Site Accessibility Evaluation

Americans with Disabilities Act Title II (Public Services: State and Local Government)

County Professional Building

**105 E Vermijo Ave
Downtown, CO 80903**

Finding 25852 Main Photo

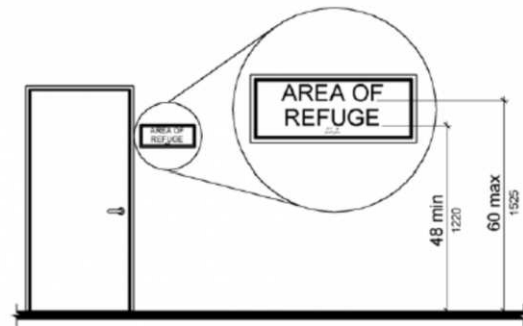
Compliant room identification signs are missing on the strike side of the door.

2010 ADAS Section: 216.2, 703.4.2

No room identification sign

Submit a work order to have sign installed adjacent to front as depicted in photo.

Corrective Action: W/O 381203 submitted. Completed 2/24/2017.

Finding 25855 Main Photo

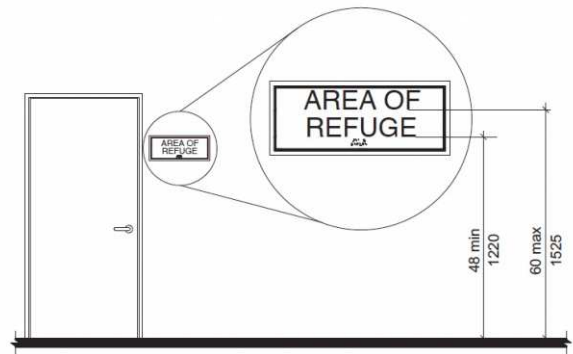
The wall sign is mounted too high.

2010 ADAS Section: 703.4.1

62 inches
high/character missing

Submit work order to have proper sign installed at proper height.

Corrective Action: W/O 381215 completed 381215.

Finding 25854 Main Photo

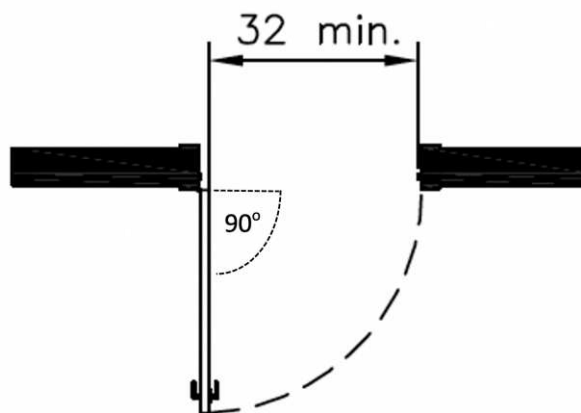
The door opening does not provide at least 32 inches between the face of the door and the opposite stop.

2010 ADAS Section: 404.2.3

Double door, each side
opens 29 inches

Submit a work order to have doors adjusted/replaced. Bill Dieter spoke w/Kim Short, she said that the public no longer uses this area and that when the public goes through security they are directed to the reception area in room 101 straight down the hall.

Corrective Action: W/O 381260 submitted. Corrective Action no longer needed due to process change.

Finding 25857 Main Photo

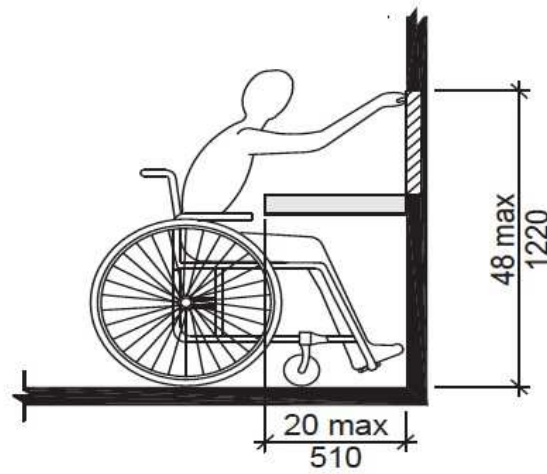
The clear floor space only allows for a forward approach and the brochure rack is out of reach range.

2010 ADAS Section: 308.2.2

Brochure rack located
behind chair

Lower brochure rack to a maximum reach of 44 inches or move to different location.

Corrective Action: W/O 381214 completed 02/09/2017.

Finding 25877 Main Photo

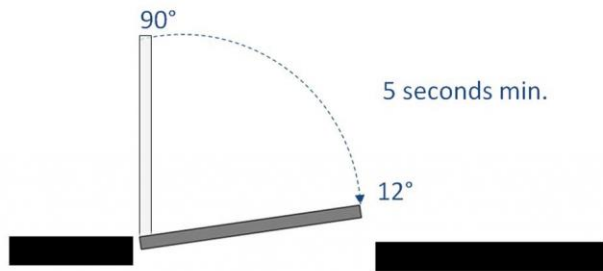
The door is equipped with a door closer and returns to a closed position too quickly.

2010 ADAS Section: 404.2.8.1

4 seconds to closed position

Adjust door closer to allow a minimum of 5 seconds to move from the open position at 90 degrees to 12 degrees from the latch/locking mechanism.

Corrective Action: W/O 381213 completed 2/9/2017.

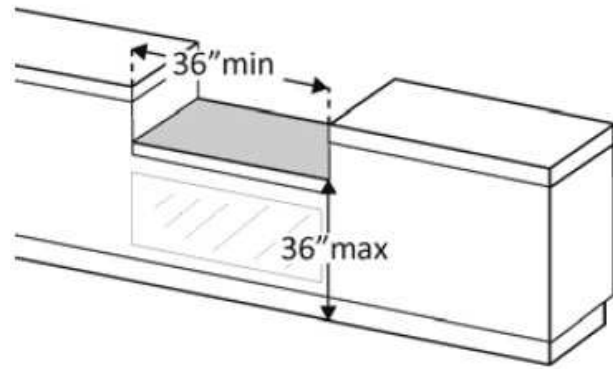
The transaction counter is too high.

2010 ADAS Section: 904.4.1

36.25 inches above
finished floor
